CITY OF BOULDER  
Planning and Development Services

## LAND USE REVIEW RESULTS AND COMMENTS

DATE OF COMMENTS: May 5, 2017  
CASE MANAGER: Elaine McLaughlin  
PROJECT NAME: Academy on Mapleton Hill  
LOCATION: 311 MAPLETON AV  
COORDINATES: N04W08  
REVIEW TYPE: Site Review, Use Review, Rezoning  
REVIEW NUMBER: LUR2016-00065, LUR2017-00027 and LUR2017-00028  
APPLICANT: MICHAEL BOSMA  
DESCRIPTION: Application for a congregate care facility consisting of 51 Assisted Living units; 95 Independent Living Units less than 1,200 square feet in size with kitchens; and 36 Independent Living Units greater than 1,200 square feet in size with kitchens. The dwelling unit equivalency is a total of 77 dwelling units. Proposal also includes a warm water therapy pool. Intended as a full continuum of care including independent living, assisted living, short term rehabilitation and memory care.

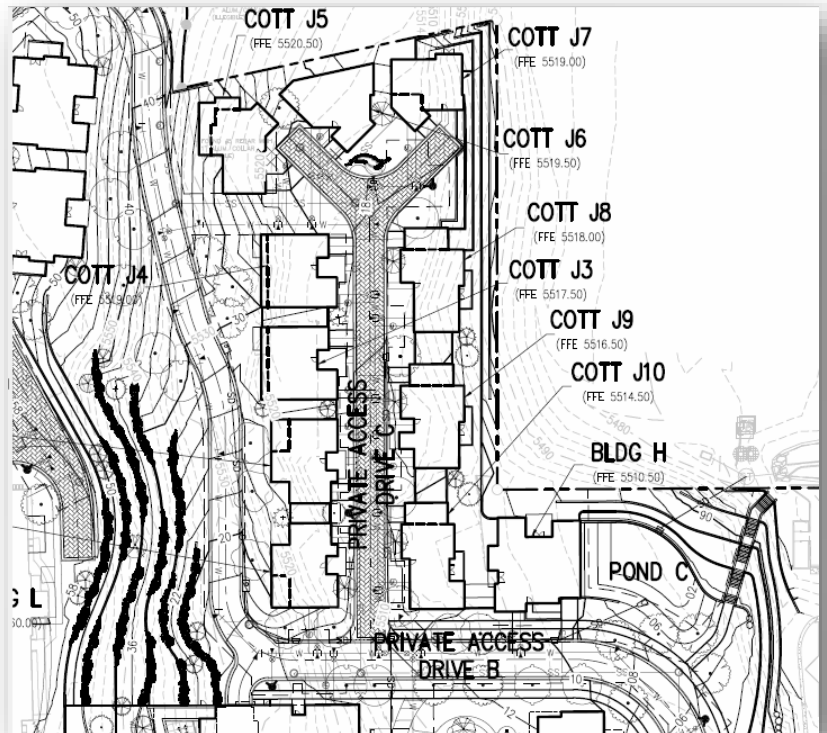
- e. Also regarding the cut and fill criterion, the northern plateau (plinth) in which buildings J1 through J10 are currently illustrated also requires a significant amount of fill on the east side of this area, along with a series of four retaining walls, some also up to seven feet in height.

It appears as though the means to achieve the 10 buildings in this location is through significant cut on the slope to the west and filling the slope to the east. This would not meet the criterion regarding minimizing cut and fill on the site, nor do the design of these buildings conform to the natural contours of the land.

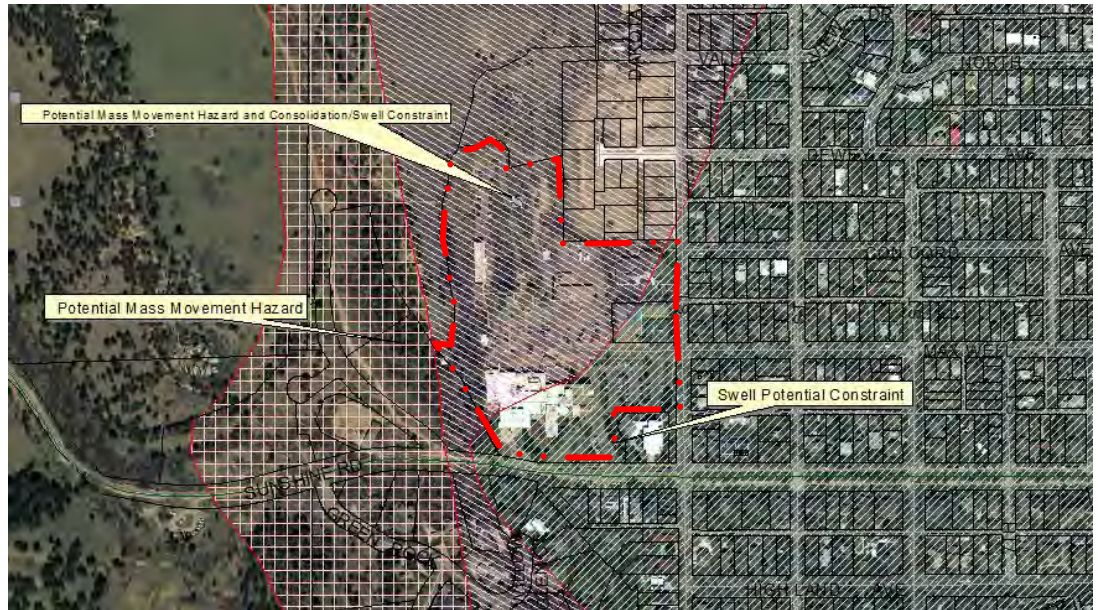
- Regarding compliance with Ordinance 8172, note that under the definition of a “story” a basement is a story if any portion of the space included between the surface of the floor and the surface of the ceiling above it extends more than two feet above the natural grade around the perimeter. Given that the height modifications may only occur per ordinance 8172, there are areas of the “basement” or below grade parking structure that would qualify as a “story” and thus not be permitted as number of stories under this provision is not permitted.

- Regarding Building A: as currently shown, the access into the parking structure along with the area considered a “podium” for the below grade parking (shown to extend above the grade) does not present a public street face to the building along Mapleton Avenue. The building should be redesigned at this critical corner to create greater pedestrian orientation.

BVCP Land Use Map of the Site

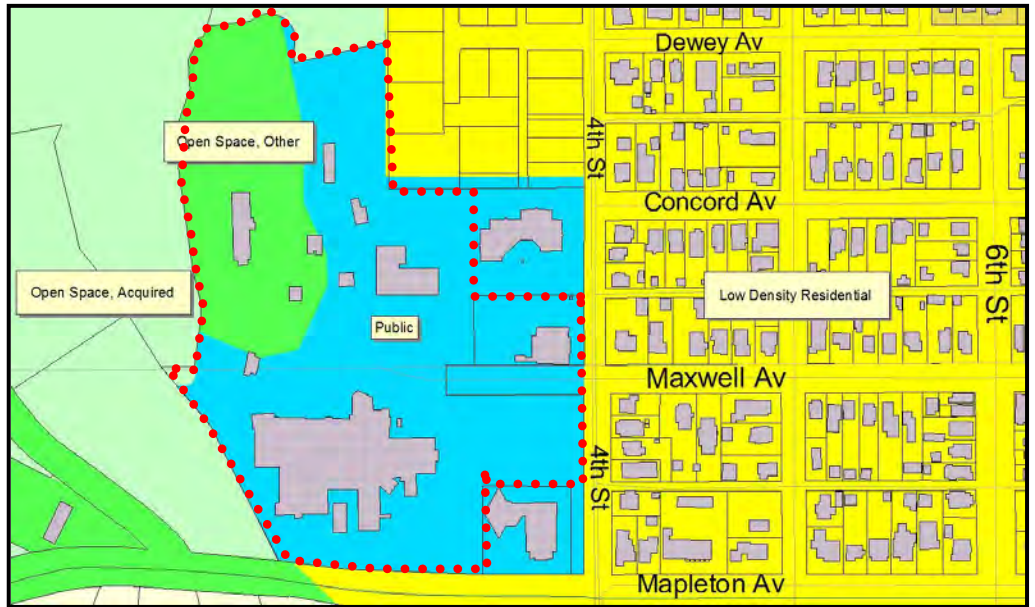
3. The Land Use Designation of Open Space – Other on the site, shown below, would need to be amended to allow the application to be consistent with the site review criteria which requires that the development is consistent with the land use map. Given that the area of the site labeled as OS-O has been developed for decades as the Nurses Dormitory, built in 1930, and with parking lots rather than open space, the location of the site where the OS-O designation is placed appears to be in error. The process to update the land use and correct the error, to be consistent with the zoning, can be processed through the BVCP update process. As a part of the process, the correction of the mapping will require referral to the Open Space Board of Trustees.

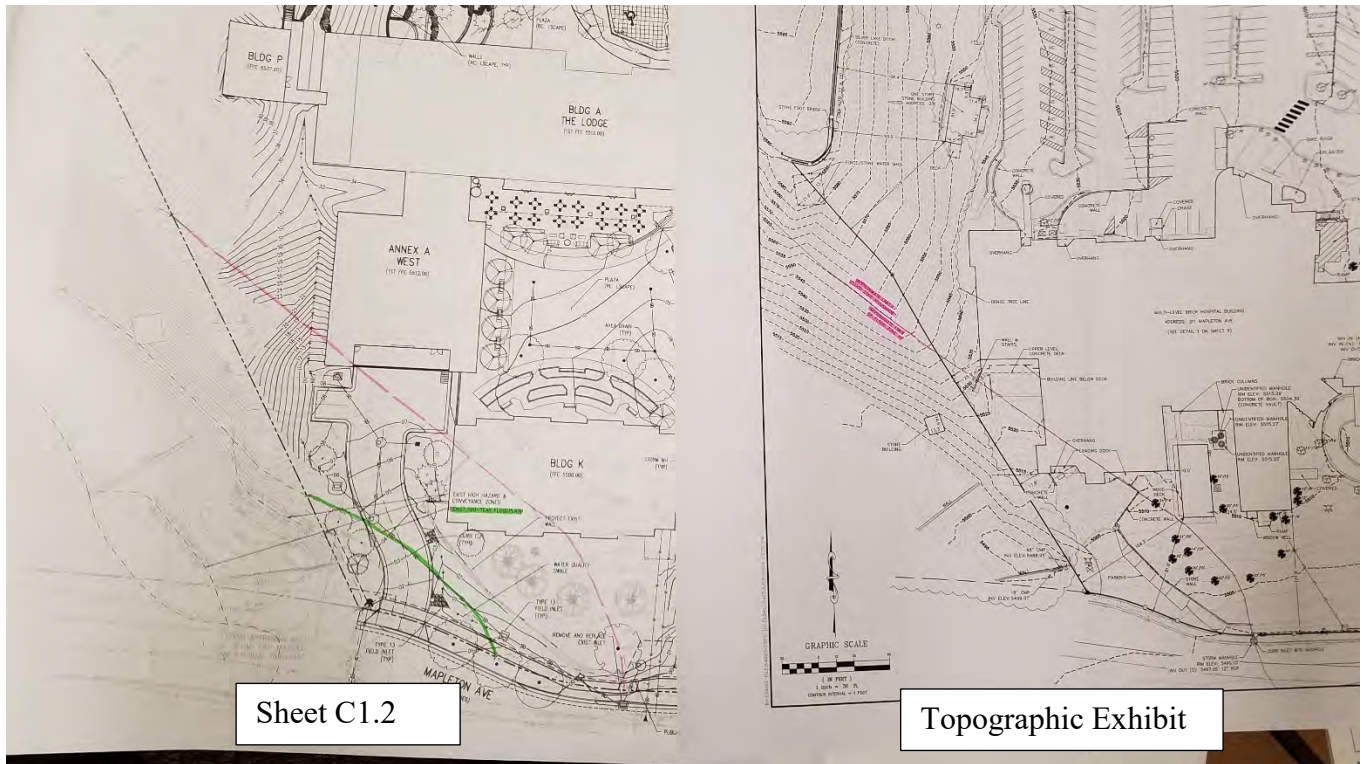
On sheets C1.7 to C1.10, the applicant provided an exhibit that illustrates areas of cut and fill. In making findings for a site review criterion, staff must indicate how "cut and fill is minimized" and balance that finding with other site review criteria. The applicant has provided an "Earthwork Calculations" summary that indicates the net result of the cut and fill is approximately 9,342 cubic yards. Staff requests the applicant provide the calculations in cubic yards of cut for the below grade parking structures. There is Site Review criteria that also looks at ensuring well-designed buildings and landscaping be the dominant visual features of a site plan and not parking. To help decision makers evaluate the balance of these two criteria, please help identify the grading extent to ensure below grade parking that will reduce the visual appearance of vehicles on the site.

2 BUILDING A NORTH - EAST ELEVATION  
1/16" = 1'-0"

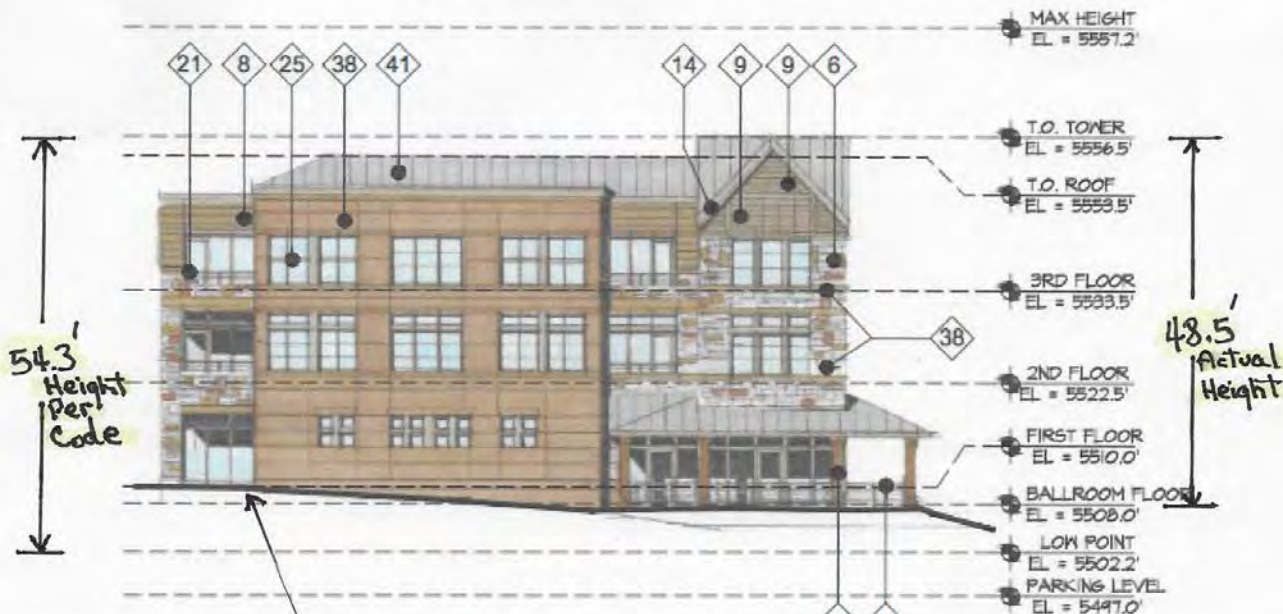
Note that for Building A, the applicant is illustrating three different low points. For each wing of Building A to be considered as a separate building with an internal connection, per 9-7-5(d)(1)(B), B.R.C. 1981; each wing must function as a separate building per the building code: Please provide details that demonstrate the wings of Building A will be constructed as separate buildings.
